MEMORANDUM

To: Emily Anderson, Wild Salmon Center
From: Cameron Wobus, PhD., Lynker Technologies, Robert Prucha, PhD., Integrated Hydro Systems
Subject: Comments on Pebble Project Final EIS
Date: August 19, 2020

Figure 1. Conceptual level drawing of tailings in bulk TSF with coarse (yellow), medium (orange) and fine (tailings) segregated into ~1000 ft long parcels. Source: FEIS Figure K4.15-3

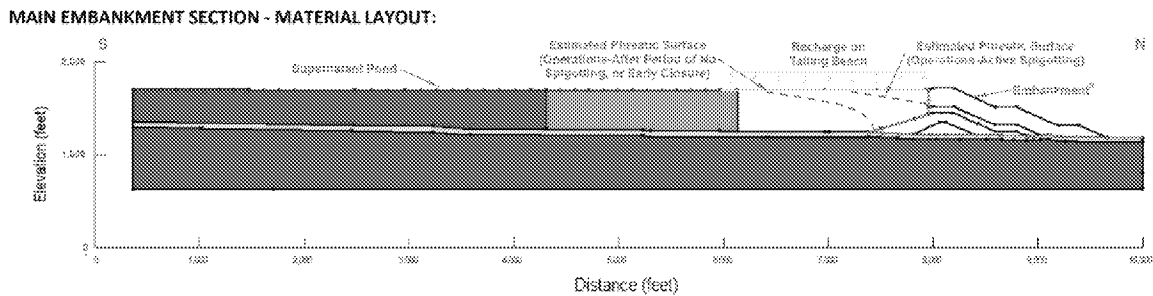
Figure 1 is an illustration of the tailings segregation zones as currently conceptualized in the FEIS. As drawn, this highly idealized cartoon suggests that these segregation zones will be thousands of feet long, with coarse, transition and fine tailings in discrete packages.

Thickened tailings will develop beaches and perform differently from whole slurry tailings such as 25% solids/75% water [...] and may not segregate to drain more freely as assumed. The consolidation time required to gain any improvements in strength are not described. **A well graded, unsegregated, low-permeability, thickened tailings deposit could result in significantly different predictions about stability and seepage performance than described for the “flow-through structure” and the apparent inconsistency with segregated tailings shown in Figure K4-15.3 should be resolved** (ADNR, 2020).

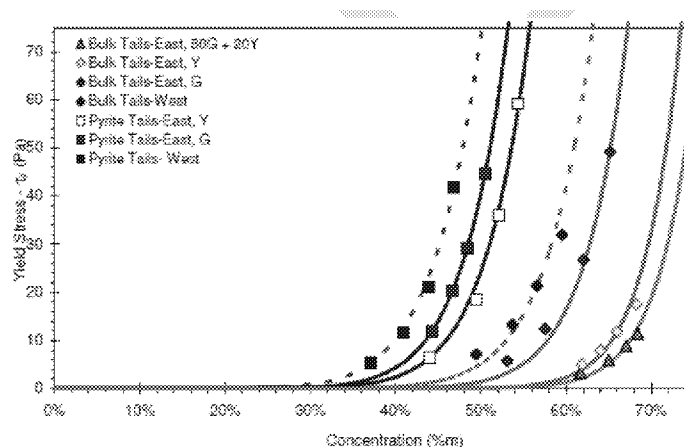
The tailings proposed for the Pebble Mine bulk TSF will be 55% solids by weight, lower than the range quoted by MEND (2017) for “thickened” tailings. Based on available tailings testwork completed by PLP, the yield stress of the bulk tailings at a 55% mass concentration will be less than 15 Pa, and will likely be less than 5 Pa (Figure). Furthermore, other parts of the FEIS state that the bulk tailings “with 55 percent tailings solids and 45 percent contact water, would be expected to flow readily (as a Newtonian fluid)” (FEIS, p. 4.27-108). The bulk tailings described in the FEIS will therefore behave much more like fluid than the “thickened” tailings described in MEND (2017), and would travel substantially further downstream. **The comparison of the bulk tailings to “thickened” tailings described by MEND (2017) is therefore inaccurate, misleading, and inconsistent with other statements within the FEIS.**

Figure 4. Input precipitation used in Watershed Module. Note sharp breaks in precipitation between sub-catchments, commonly creating artificial jumps in precipitation exceeding 20-30 inches across subcatchment boundaries. Source: Figure 3.6 of KP, 2018a

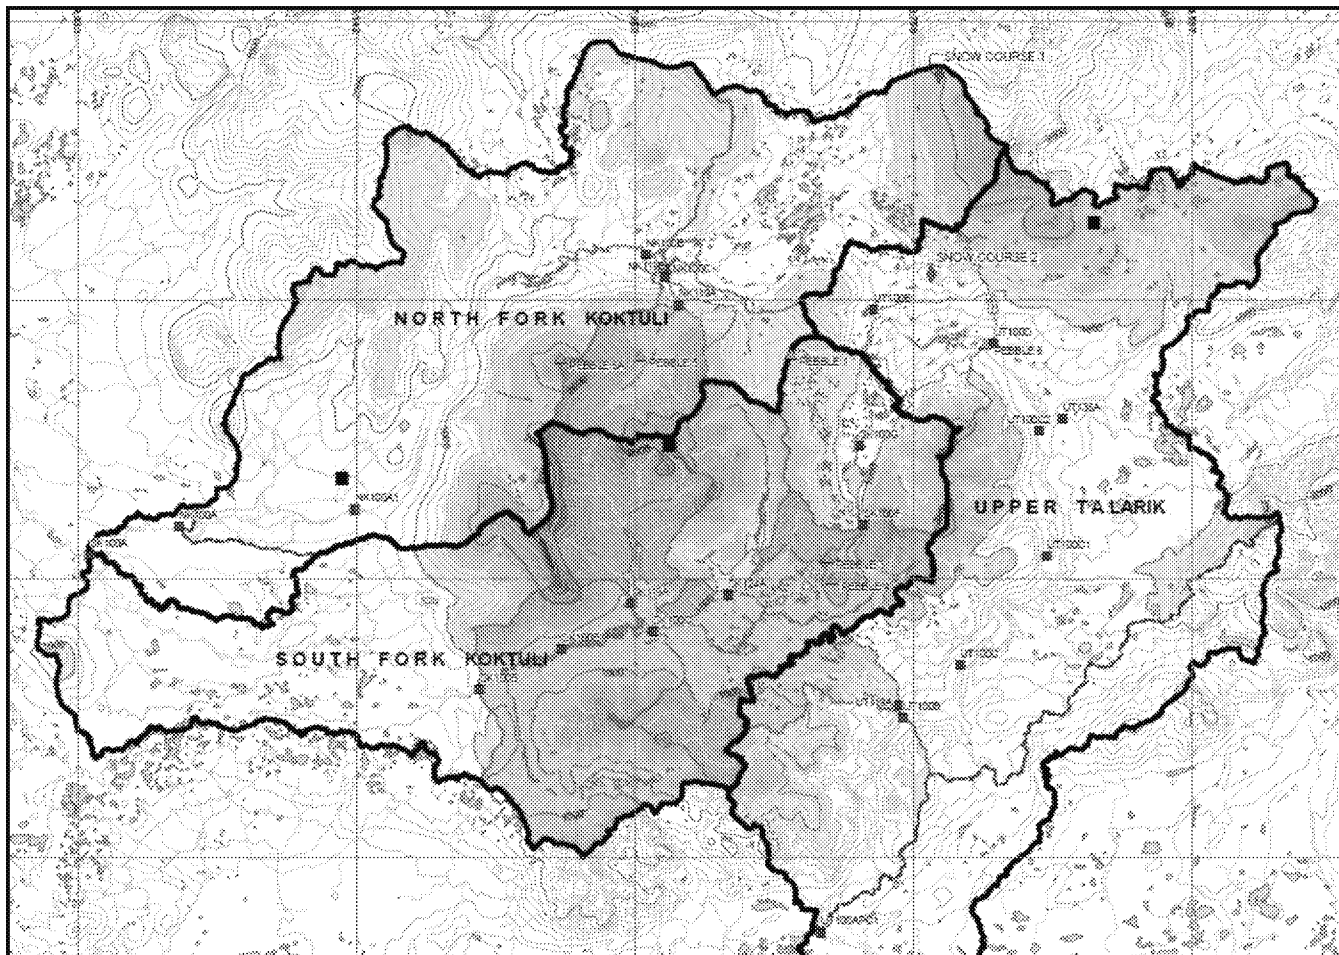
Put another way, the Watershed Model – which is used to support virtually all of the hydrologic projections in the FEIS – simply adjusts the basin-averaged precipitation values to ensure that there is a match with measured streamflow, on a monthly basis, at the scale of each sub-catchment. This is the nature of the "local precipitation factor" described in point #2 of RFI 138, and it creates a physically implausible patchwork of basin-averaged precipitation inputs, as shown in Figure below.

Note that the precipitation inputs to the Watershed Model are discontinuous, in some cases jumping by 30 inches or more across basin boundaries (e.g., the SK119A vs NK100A1 basins), and in other cases decreasing with elevation rather than increasing, as the orographic factor requires (e.g., SK100F vs SK100C basins) (Figure). This physically implausible distribution of input precipitation is a result of tuning the precipitation in the Watershed Model to match the streamflow measurements – which are the only measured calibration targets for the model. Furthermore, the Watershed Model ignores the spatially distributed, site-specific precipitation records that were collected at 6 stations, at elevations ranging from 800 ft to 2,300 ft, and it relies instead on a synthetic meteorological record generated from the Iliamna airport station – approximately 17 miles southeast of the mine site (Knight Piesold, 2018b) – to drive the watershed module.

Figure 5. Grain size distribution of bulk tailings. Source: Knight Piesold (2018a).

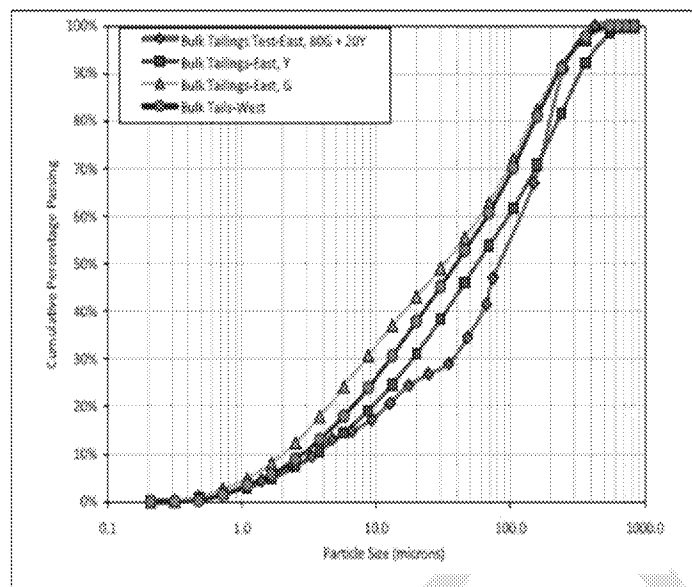
These data indicate that the 10th percentile of the tailings grain size distribution ranges from approximately 2 to 4 microns, and the 60th percentile of the grain size distribution ranges from approximately 60 to 120 microns

(Figure). Based on these values, we used two empirical relationships to estimate the bulk hydraulic conductivity of the tailings (e.g., Wang et al., 2017). The Hazen equation predicts a bulk hydraulic conductivity of $9.5\text{e-}8$ to $3.8\text{e-}7$ ft/s, and the Beyer equation predicts a conductivity of $1.1\text{e-}7$ to $4.2\text{e-}7$ ft/s. All of these values are in line with the values used in the previous groundwater modeling effort, and are approximately an order of magnitude lower than the value used in the updated groundwater model.

Figure 6. Simulated groundwater mounding post-closure. Note the mounding of approximately 400 ft in the bulk TSF. Since this model was run in steady state only, this indicates that the central part of the bulk TSF will remain water-saturated in perpetuity (Source: BGC 2019, Figure 8-3)

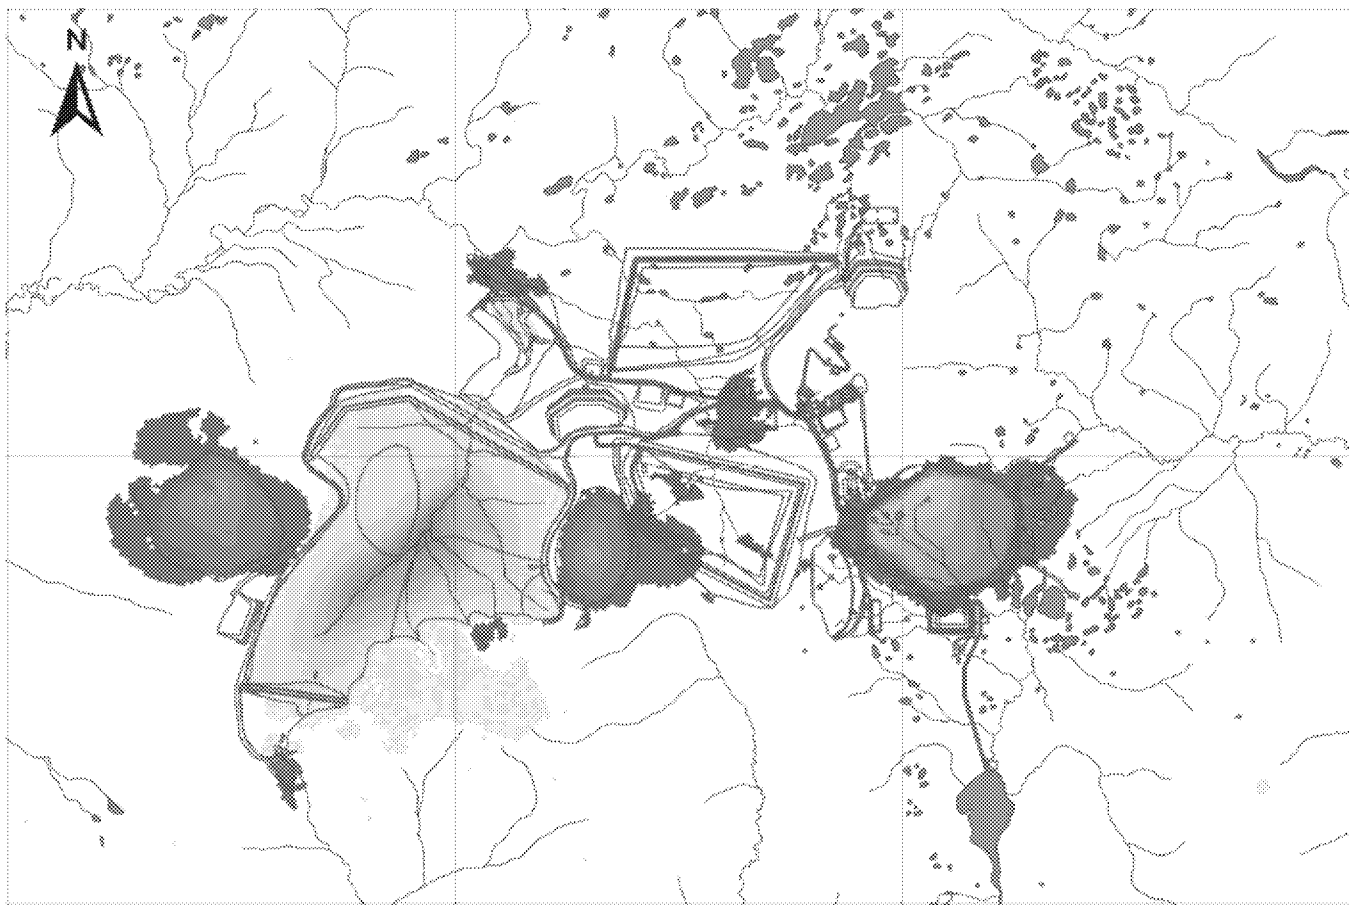
Thus with no explanation, the hydraulic conductivity of the tailings was increased more than an order of magnitude above the value indicated by available data. Yet even with this artificially high tailings permeability, the groundwater modeling results remain inconsistent with one of the most important conclusions in the FEIS from a risk management perspective: namely, that the bulk tailings will dewater and therefore minimize the risk of a large-scale tailings failure. As shown in Figure below, groundwater mounding in the bulk tailings facility - **even based on a hydraulic conductivity value that is an order of magnitude too high** - is estimated to be as high as 400 feet post-closure. Because the post-closure simulation represents steady-state conditions (BGC, 2019a), this means that PLP's own groundwater model predicts the majority of the tailings will be saturated **in perpetuity**. This modeling output is directly at odds with the "dry closure design" that the FEIS repeatedly invokes to dismiss the long-term risk of a bulk TSF failure (FEIS, p. ES-103; FEIS, p. K4.27-2).

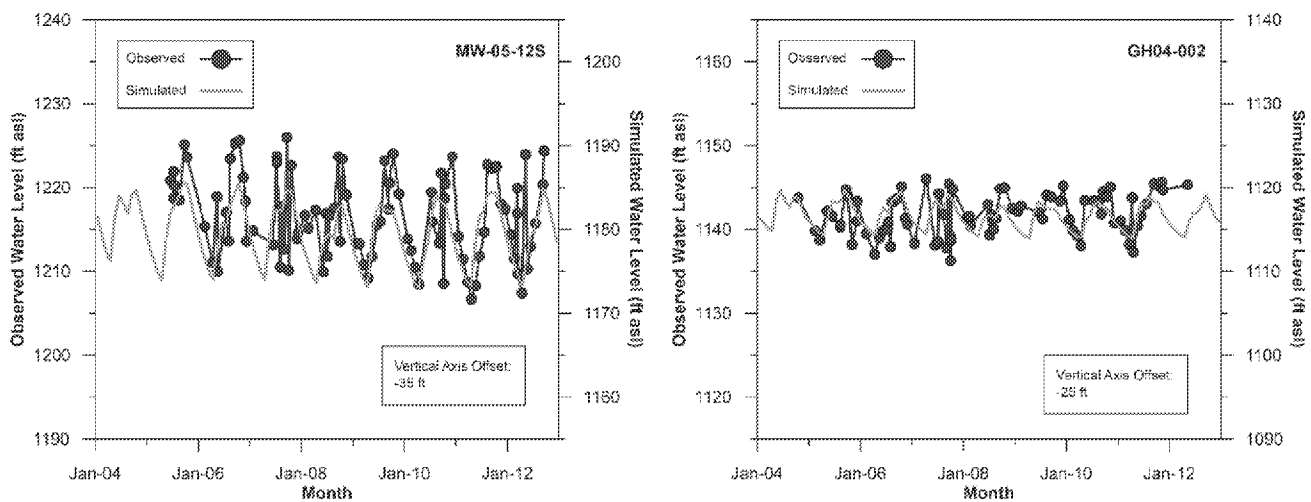
As one key illustration of this issue, Figure below shows two comparisons between observed and simulated groundwater elevations from the numerical groundwater modeling report (BGC, 2019a). The observed data from these wells are illustrative of how closely groundwater is connected to surface hydrologic processes in this system (Prucha, 2019). Based on the tables provided in the environmental baseline documents, the water table at both of these wells is very close to ground surface: MW-05-12S is at a surface elevation of 1230 ft, and GH04-02 is at an elevation of 1151 ft. Thus, actual (observed) groundwater elevations in both of these wells come within 5 feet of ground surface. Observed groundwater elevations also vary seasonally, rising and falling as much as 10-15 feet with seasonal cycles of precipitation.

At first glance, the groundwater model seems to capture the variability in groundwater elevations at these two wells: the plots were manipulated so that the simulated groundwater elevations (green) overlap with the observations (blue). However, the simulated results have very large vertical offsets, as shown by the secondary y-

Both of the wells shown in Figure are also near the proposed open pit. Since another stated objective of the model is to “quantify the rate of groundwater extraction at the proposed open pit” (BGC, 2019), a model that misses the mark on shallow groundwater elevations by ~30 feet means that these model projections are also flawed. In particular, because it is missing ~30 feet of saturated thickness in the coarse, unconsolidated materials in this area, the model will underestimate the amount of water flowing into the pit, and therefore the pit dewatering and water treatment requirements that cascade through all of the water management decisions described in the FEIS.

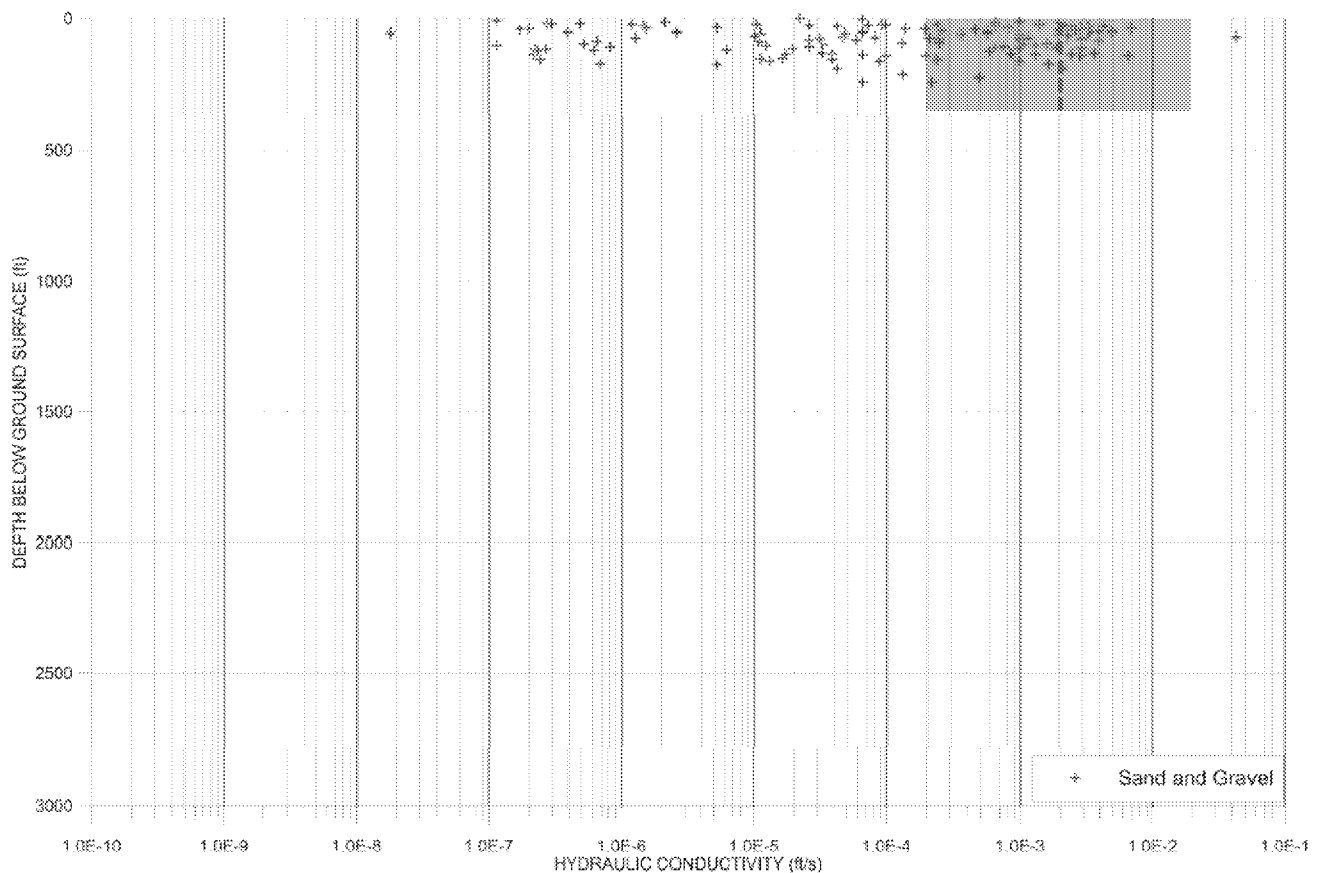
One example of this is the choice of sensitivity tests for the hydraulic conductivity (permeability) of the unconsolidated materials in the mine area. Field measurements show that the sand and gravel deposits generally have hydraulic conductivity values ranging between $1\text{e-}7$ to $1\text{e-}2$ ft/s, or five orders of magnitude (Figure). The calibrated hydrologic model used a value of $2\text{e-}3$ ft/s for hydraulic conductivity (BGC 2019 Table 6-1), and the model sensitivity tests varied this value upward and downward by one order of magnitude (BGC 2019a Table 9-2). The mean and the range of sensitivity analyses are highlighted by the blue dashed line and blue shading below.

Figure shows that the “base case” for hydraulic conductivity is near the upper end of values measured in the field, and that the range of sensitivity tests captures only the upper end of measured values. The justification for choosing a base case value of $2\text{e-}3$ for hydraulic conductivity is that this value produced the best calibration based on the calibration targets chosen (BGC, 2019a). However, as illustrated in Section 2.2.3 above, the calibrated model still remains well off the mark in terms of simulating shallow groundwater conditions, which are among the most important metrics to get right if the model is used to estimate environmental impacts of mining. Furthermore, in complex models typically a wide range of parameter sets exist that can simulate baseline conditions equally well – a concept referred to as equifinality. But while many parameter sets may reproduce baseline conditions equally well, any one of these parameter sets may predict significantly different results once the system is perturbed under future mining conditions. The groundwater modeling report notes that the choice

of hydraulic conductivity for unconsolidated materials “results in a significant effect on model predictions but also results in a significant effect on model calibration” (BGC, 2019a, p. v). Since the sensitivity analyses explored only a very narrow range of possible hydraulic conductivity values relative to observations, the ability of the model to predict the effects of mining is questionable.
